Attachment 1

Errata to EA

The following corrections apply to the Environmental Assessment (EA) and accompanying discipline reports for the SR 518/SeaTac Airport to I-5/I-405 Interchange Project, which was issued on May 31, 2006. These corrections serve to clarify or enhance readability of the EA. Because these changes to the EA neither alter the analysis nor the conclusion of No Significant Impact, the issuance of a revised EA is not required. Changes to the EA text are identified by the corresponding page number in the EA. These minor revisions are incorporated into the EA by reference.

Exhibit 4-3: Comparison of Noise Levels at Each Noise Barrier Location

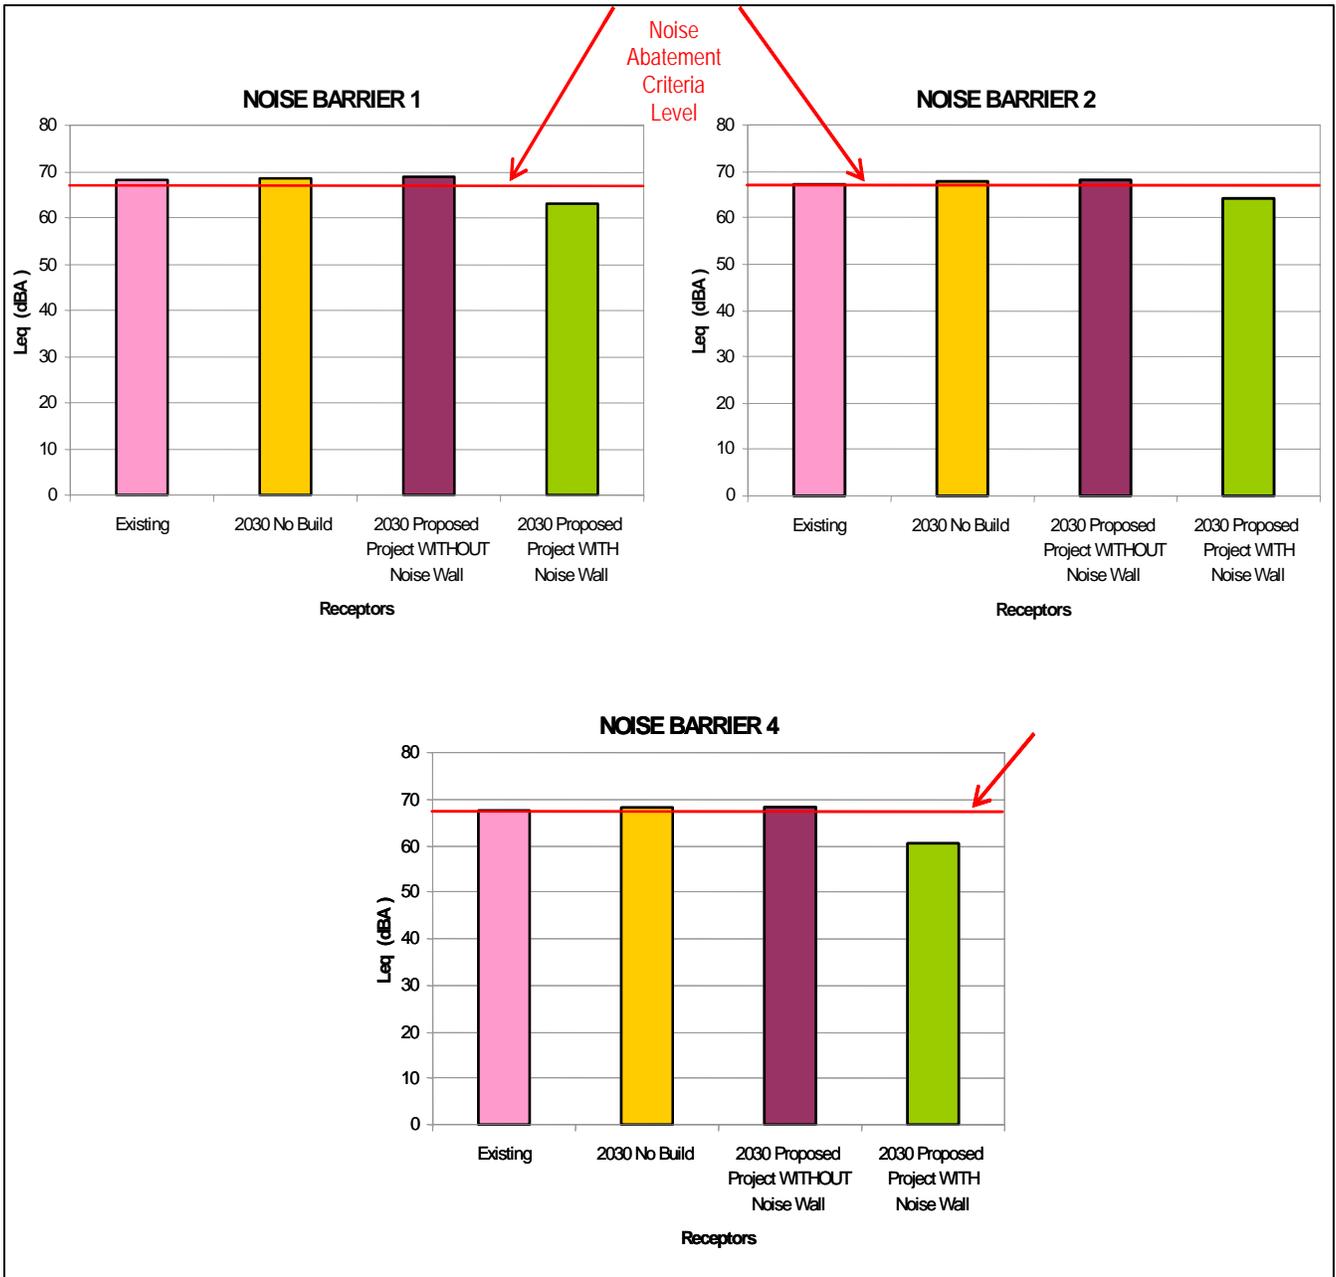
Page 4-8, Exhibit 4-3: Comparison of Noise Levels at Each Noise Barrier Location, has been revised. Specifically, the bar graph height for Noise Barrier 4 was increased for “2030 Proposed Project WITHOUT Noise Wall” to illustrate that future noise levels in 2030 with the Proposed Project but without Noise Barrier 4 would exceed the Noise Abatement Criteria (NAC) established by FHWA (see Exhibit 4-3).

Exhibit 4-12 (Sheet 1): Environmental Assessment Exhibit 4-12 and Ecosystems Discipline Report Exhibit 4: Wetlands and Streams in the Project Area

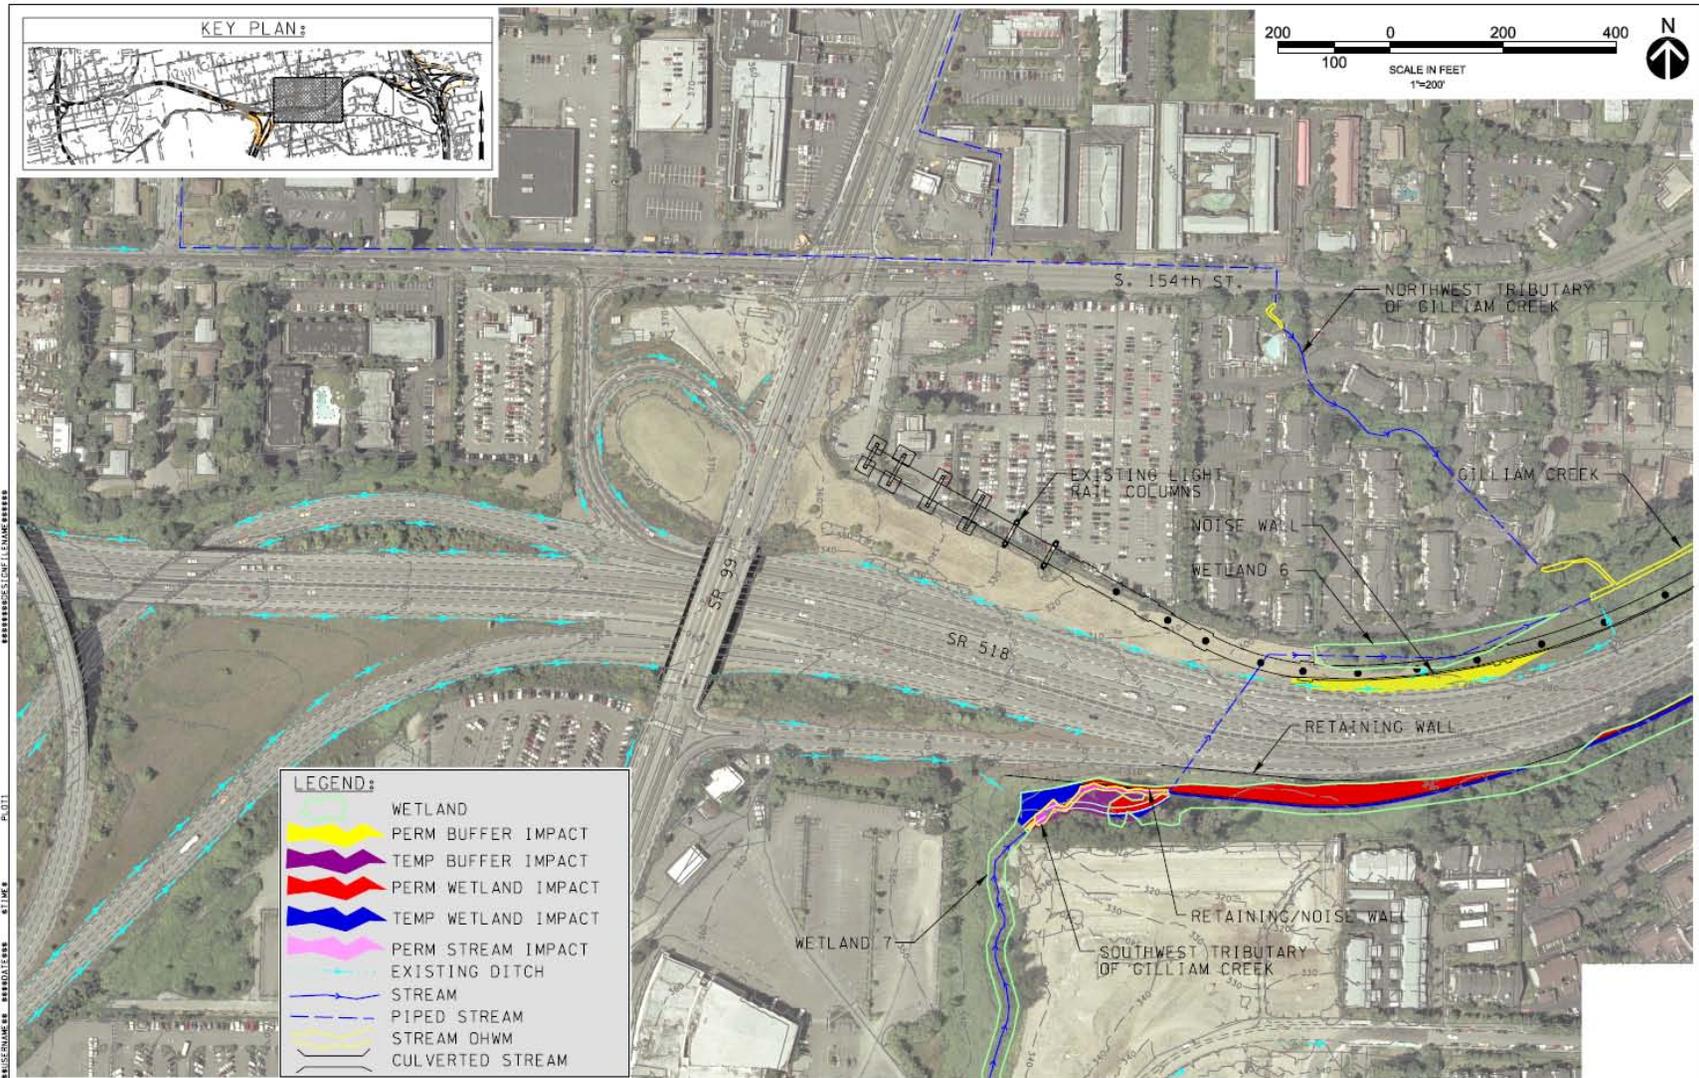
Pages 4-34 through 4-36, Exhibit 4-12 (Sheets 1, 2, and 3) have been updated to show revised wetland impacts (see Exhibit 4-12, Sheets 1, 2, and 3).

Page 2-7, Exhibit 4 has been revised (see preceding Exhibit 4-12, Sheet 1).

Exhibit 4-12 (Sheet 2): Environmental Assessment Exhibit 4-12 and Ecosystems Discipline Report Exhibit 5: Wetlands and Streams in the Project Area

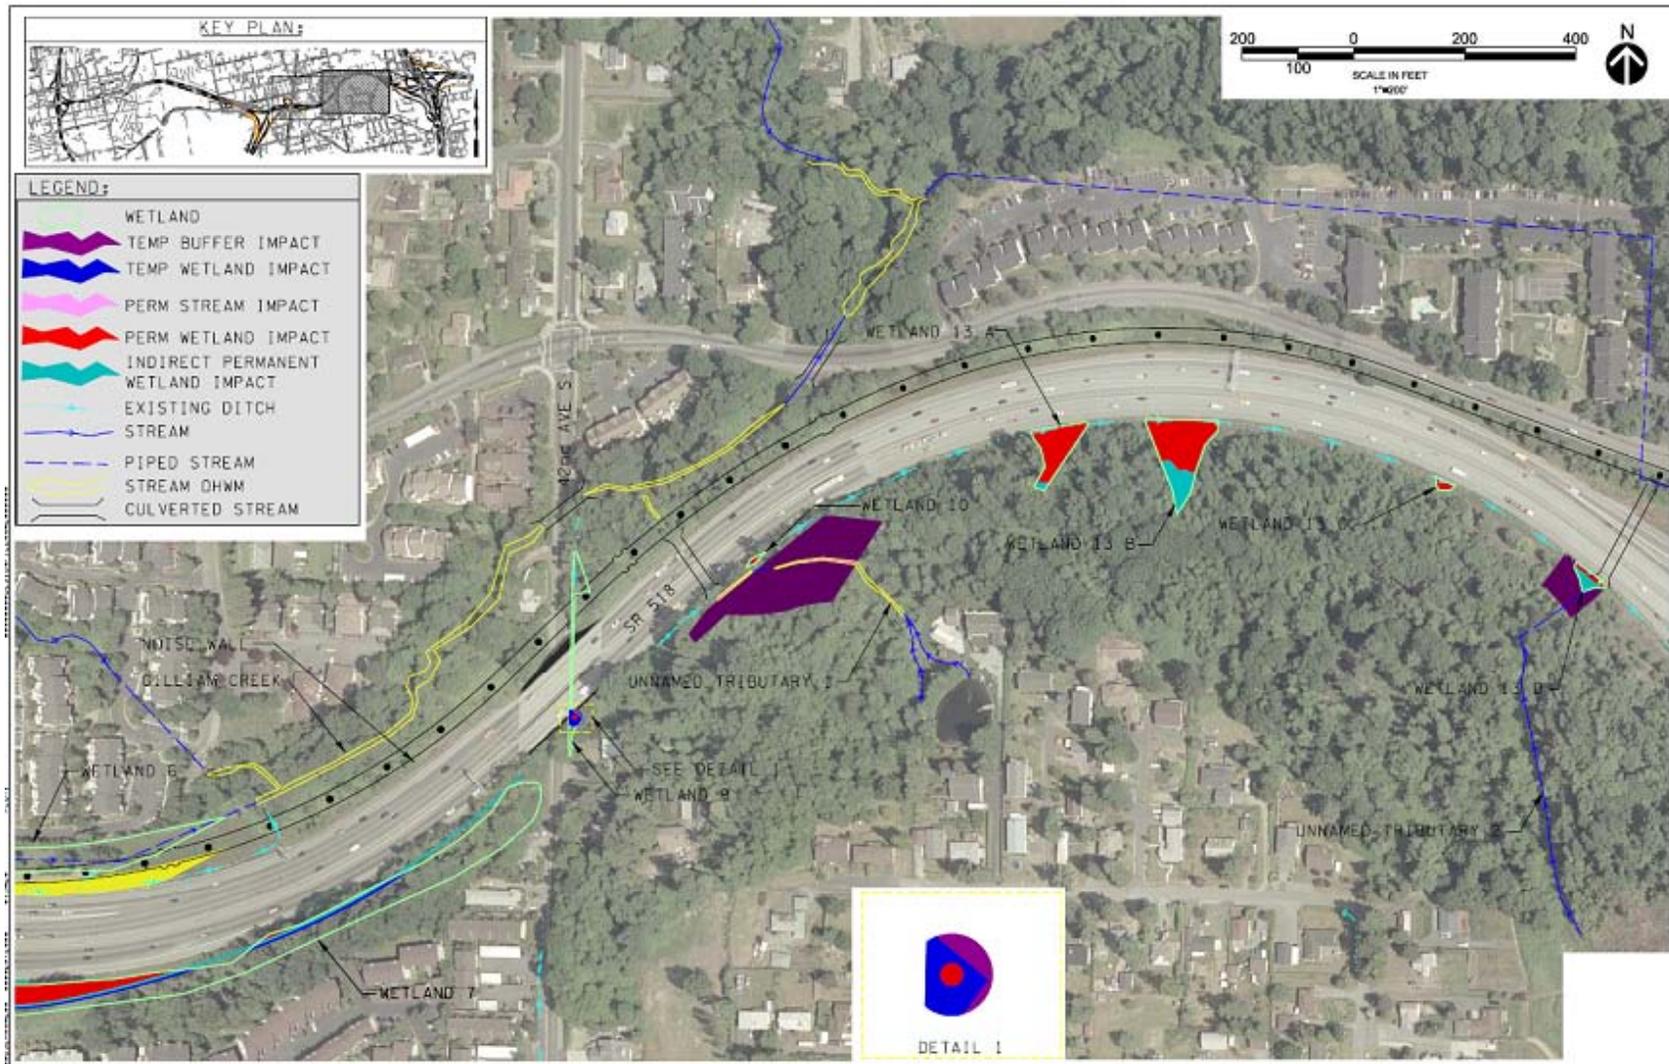
Page 2-8, Exhibit 5 has been revised (see preceding Exhibit 4-12, Sheet 2).

Exhibit 4-12 (Sheet 3): Environmental Assessment Exhibit 4-12 and Ecosystems Discipline Report Exhibit 6: Wetlands and Streams in the Project Area

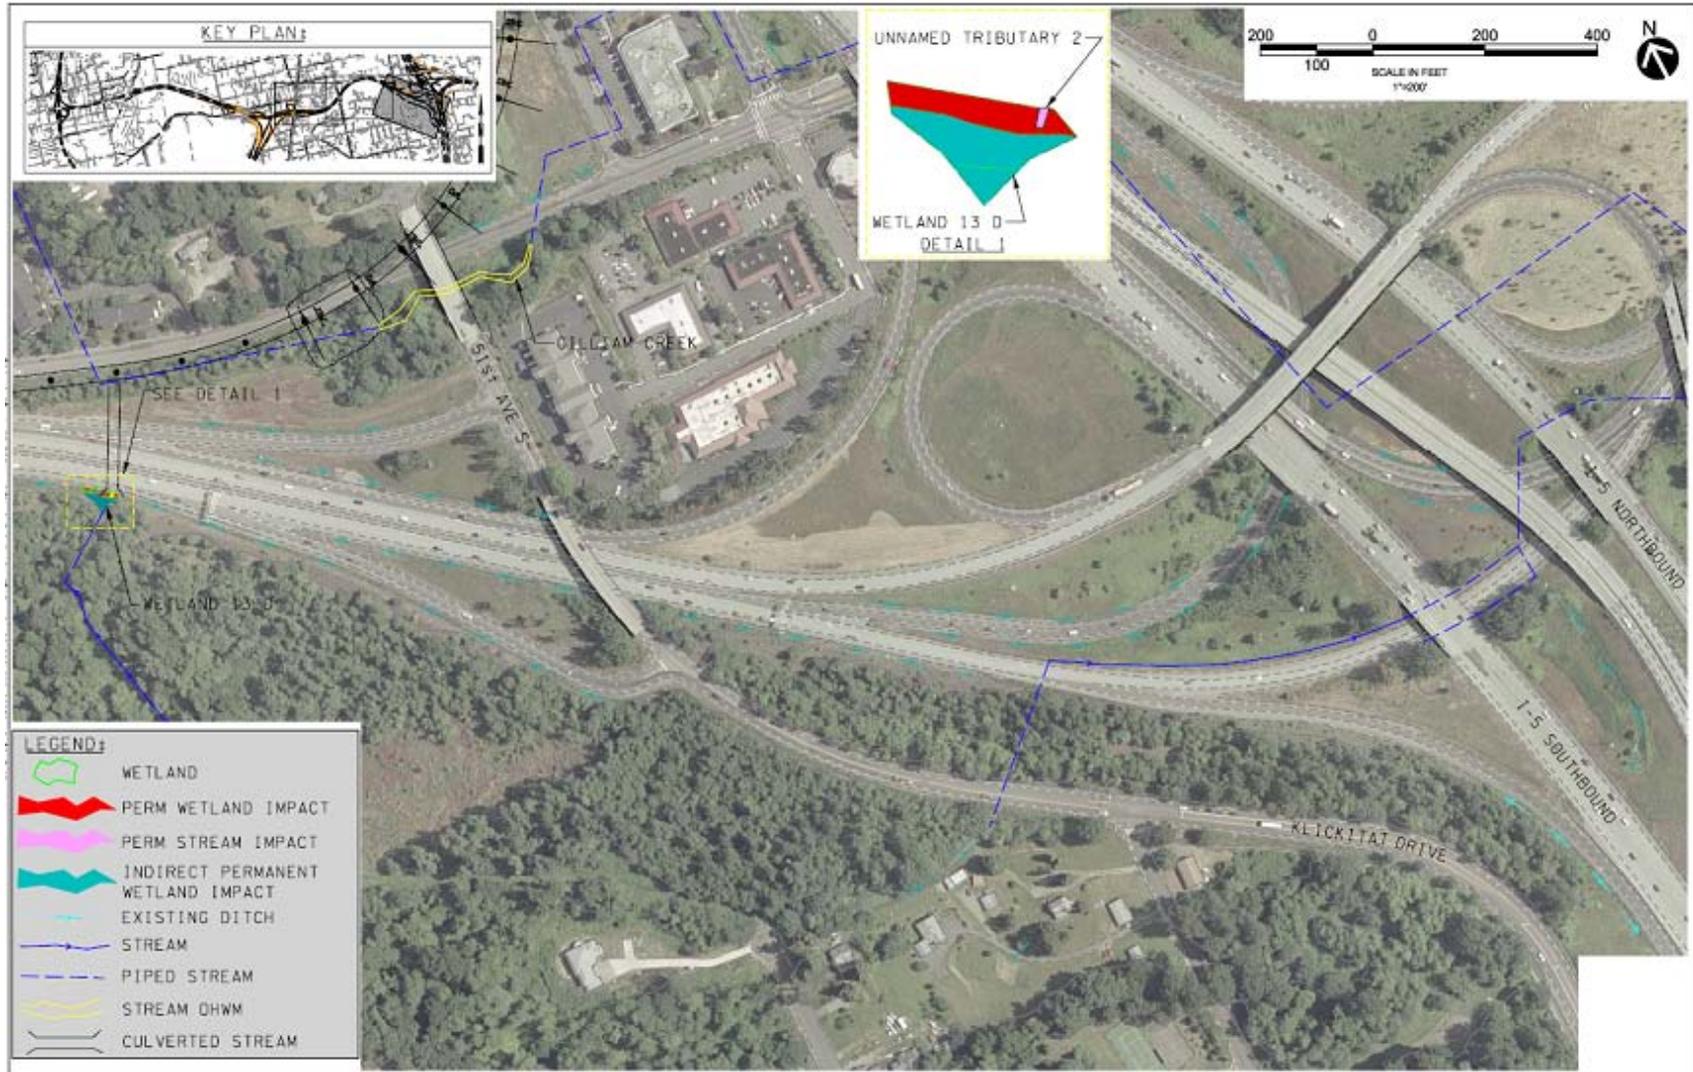
Page 2-9, Exhibit 6 has been revised (see preceding Exhibit 4-12, Sheet 3).

Exhibit 6. Wetlands, Streams, and Ditches in the Central Portion of the Project Area

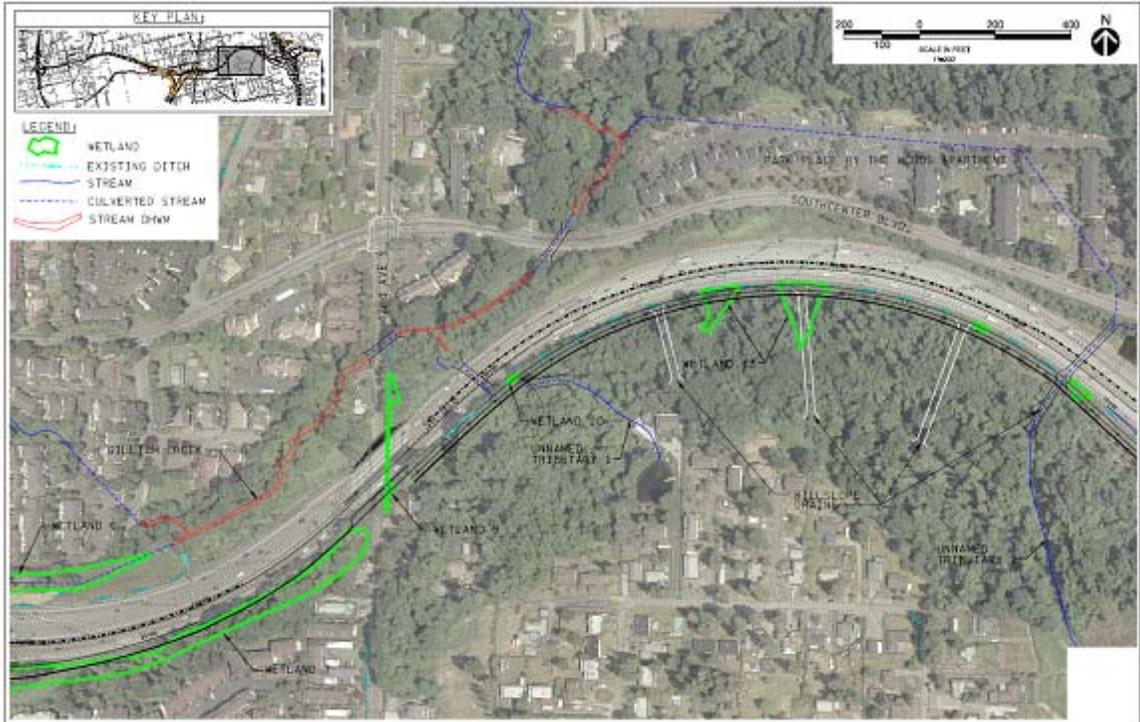
Page 2-7, preceding the heading, “HOW IS STORMWATER RUNOFF CONVEYED TO SURFACE WATERS IN THE PROJECT AREA?,” a new paragraph has been added as follows: “*There are two additional tributaries to Gilliam Creek within the project area. These tributaries, called Tributary 1 and Tributary 2 for the purposes of this project, drain portions of the wet hillslope to the south of SR 518 between 42nd Avenue South and 51st Avenue South. Flow in these tributaries is conveyed north to Gilliam Creek in separate 24-inch-diameter culverts beneath SR 518. Tributary 1 enters Gilliam Creek just east of 42nd Avenue South via a short section of open channel downstream of the culvert outlet (Exhibit 6). Tributary 2 enters a piped section of Gilliam Creek in a manhole drop structure located on the embankment south of Southcenter Boulevard (Exhibits 6 and 7).*”
